ADA Curb Ramp New Construction Inspection Form (Parallel)

Nw 314th ave

24952.54

Nw. Commercial st.

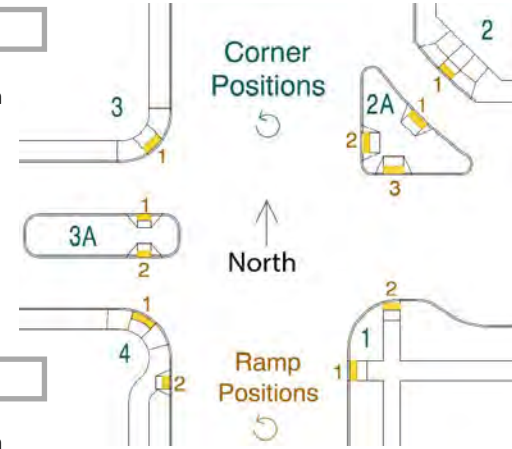
15.2 $\leq 2.0\%$ ☐ $> 2.0\%$ ☒

6.9 $\leq 2.0\%$ ☐ $> 2.0\%$ ☒

1.0 $\leq 1/4"$ ☐ $> 1/4"$ ☒

☐ 9 $\leq 8.3\%$ ☐ $> 8.3\%$ ☒

5.1 $\leq |5.0\%|$ ☐ $> |5.0\%|$ ☒

3.5 $\geq 4.0'$ ☐ $< 4.0'$ ☒

1 $\leq 1/2"$ ☐ $> 1/2"$ ☒

No dome, no RR2, no RR3
